# ADA Curb Ramp New Construction Inspection Form (Perpendicular)

NW Main

23885.56

NW Lenox

## PERPENDICULAR RAMP (PR)

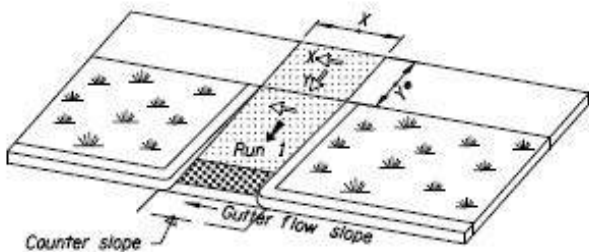
DWS IITD Fails RR 1
